**OC PLANNING REPORT**

**SUBJECT:** Public Hearing on Planning Application PA20-0089 for a Use Permit and Variance

**PROPOSAL:** A request for a Use Permit and Variance for deck and wall improvements at an existing residence. A Use Permit is required for the construction of a service yard screen wall at a height of 9 feet within the front setback where Zoning would otherwise permit a maximum height of 3 feet 6 inches. A Variance is required to allow for a reduced front setback of 5 feet 9 inches for a new deck and support columns where the Zoning Code would otherwise require 16 feet 11.6 inches pursuant to the shallow lot provisions of the Code. The screen wall and deck support columns would generally match the existing front setback. Minor grading relating to the proposed improvements would also be proposed.

**LOCATION:** The project is located in the community of Emerald Bay at 522 Emerald Bay, Laguna Beach, CA within the Fifth Supervisorial District (APN 053-081-05).

### Existing Front Elevation

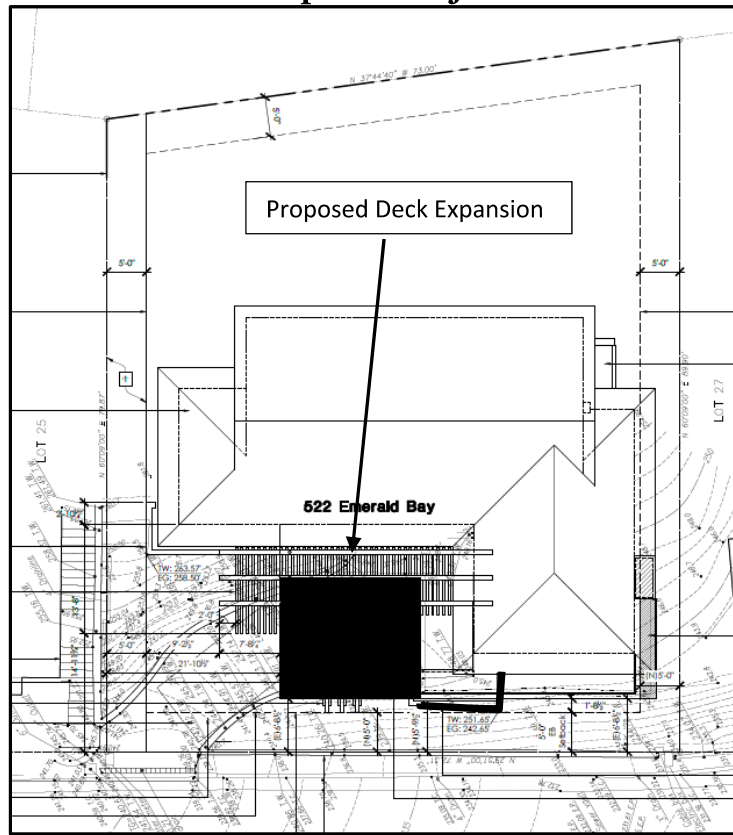
The subject property qualifies as a shallow lot with an average depth of 84 feet 10 inches. This would permit a rear setback of 16 feet 11 inches (20% of 84 feet 10 inches). The project proposes a 5-foot 9-inch setback for the support columns for the deck expansion. It is noted that the proposed support columns would be in line with the existing conforming setback of the garage area and living space above it.

### Project Detail

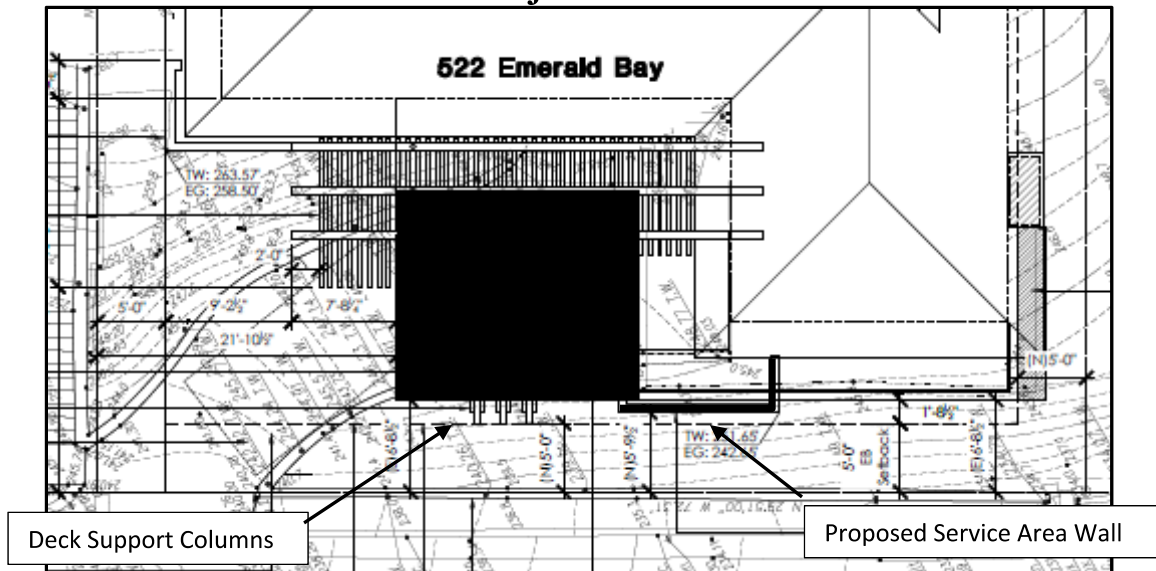
Staff finds that the special circumstances relating to the property include its existing nonconforming status, its sloping topography, and its location in a coastal community with strict architectural guidelines. All of these are unique aspects to the subject lot and vicinity when compared to other R1 zoned properties within the County. Combining the constraints of a shallow lot with the existing nonconforming setbacks presents special constraints to the development of the property.

### Proposed Over-Height Screen Wall

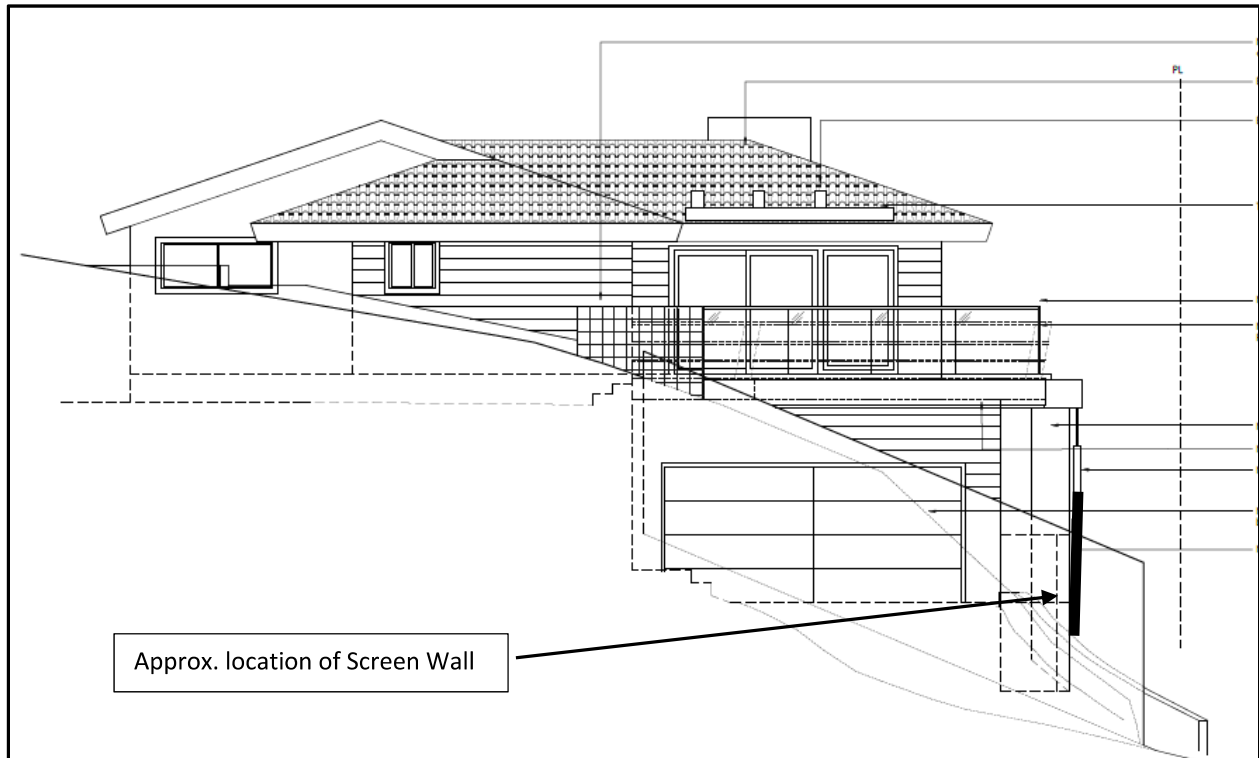
The proposed project design also includes a screening wall for a new service area that will be located adjacent to the existing garage entry and within the front yard setback. Due to the topography of the site dropping quickly from the proposed location down to the fronting street,

the screening wall would have a measured height of up to 9 feet.

The proposed wall will be located above and parallel to property lines along the street and will not result in or create a traffic hazard. The location, size and design of the walls are consistent with similar improvements throughout Emerald Bay and will not be objectionable, detrimental or incompatible with other permitted uses within the community. Staff recommends that the two required findings to modify permitted wall height can be made. Recommended findings are included in Attachment 1.
